MEMORANDUM

Subject: Parkside CCDC— Responses to DDOT Comments

This memorandum presents responses to District Department of Transportation (DDOT) concerns expressed during the April 4th, 2011 hearing on the Parkside Stage 1 PUD modification Zoning Commission hearing, and contained in the DDOT letter regarding the Stage 2 PUD application of the Community College of DC (CCDC), located within the Parkside development.

Existing Volumes

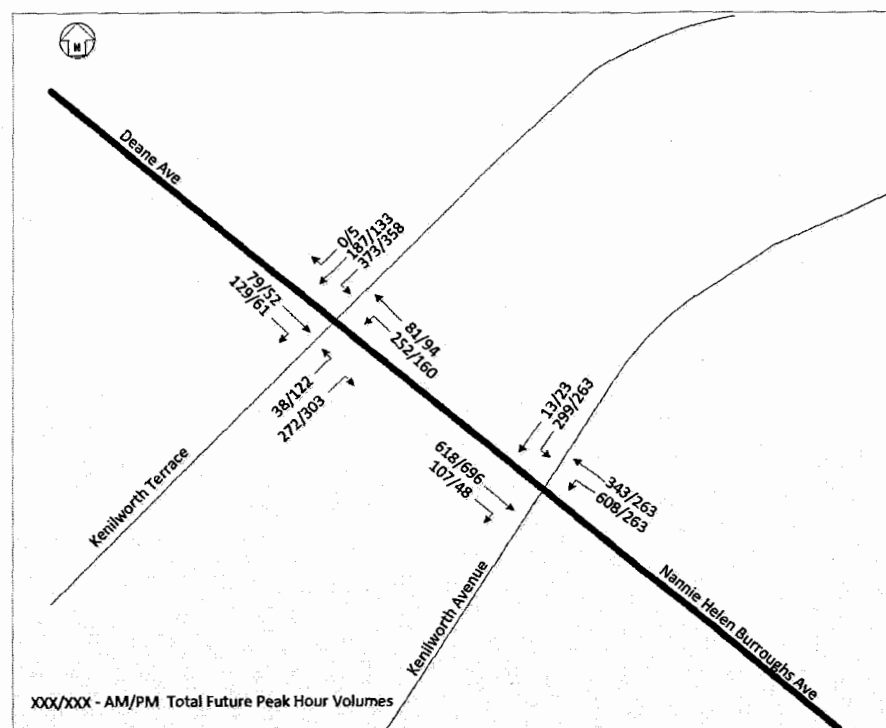
The Traffic Impact Study (TIS) performed for the CCDC development was conducted prior to final build-out of District improvements to the intersection of Kenilworth Terrace and Nannie Helen Burroughs Avenue. The TIS presented traffic model results showing projected capacity analysis results after final construction. Since the intersection construction is now complete, DDOT expressed interest that new traffic counts and an updated analysis for this intersection be performed.

The following describes the revised analysis & data collection. Manual traffic and pedestrian counts were conducted between 7:00 to 9:00 am and 4:00 to 6:00 pm on Tuesday April 12, 2011, times that matched the system peak hour identified from the original TIS. Field observations of the intersection were conducted at the same times as the counts, with the following notes:

The following graphics show existing the total future volumes for these intersections used in this analysis.

The following table contains revised capacity analysis results for both existing and total future conditions. The results show that no intersection or intersection approach operates at an unacceptable, failing Level of Service grade, under existing conditions or projected future conditions. Thus, the conclusions contained in the original TID are still valid, the modifications to the Stage 1 PUD and development of Parcel 12 will not have an adverse impact on roadways near the site.
